| Operating Code No.2 (OC2) – Comparison of Current and Proposed new Legal Text | | |

Figure 1 Requirements by USERS under OC2.3.1.3.1 Operational Planning phase – Planning for Financial Years 2 to 5 inclusive ahead

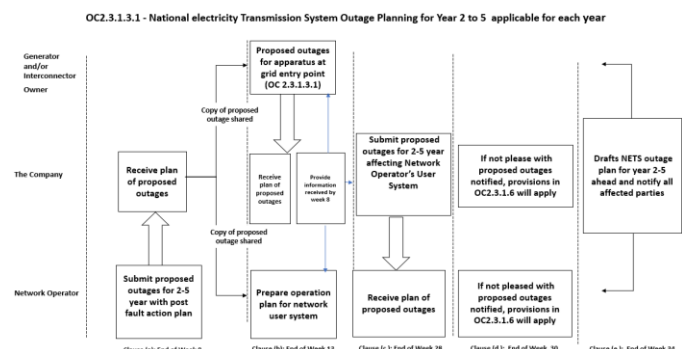
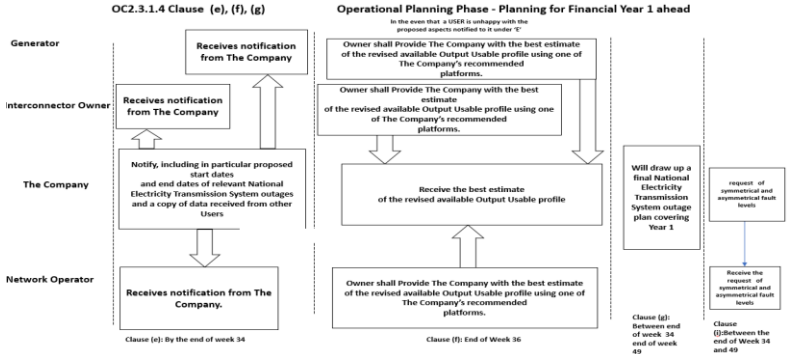
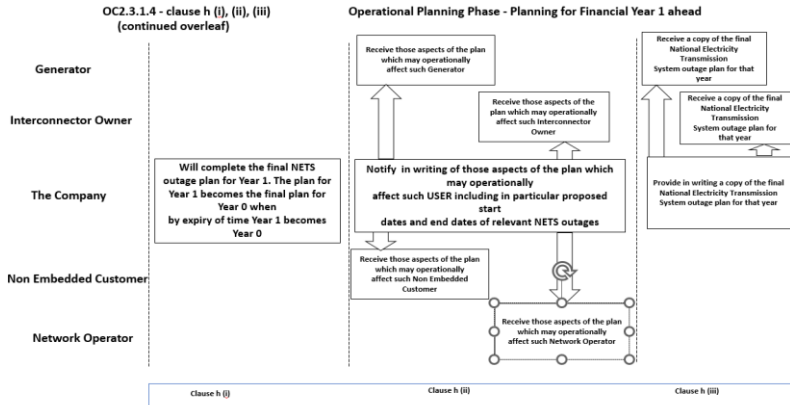
Proposed outages for apparatus at grid entry point (OC2.3.1.3.1)

Copy of proposed outage shared

Receive plan of proposed outages

Submit proposed outages for 2-5 year with post fault action plan

Prepare operation plan for network user system

Receive plan of proposed outages

Submit proposed outages for 2-5 year affecting Network Operator's User System

If not please with proposed outages notified, provisions in OC2.3.1.6 will apply

Drafts NETS outage plan for year 2-5 ahead and notify all affected parties

If not pleased with proposed outages notified, provisions in OC2.3.1.6 will apply
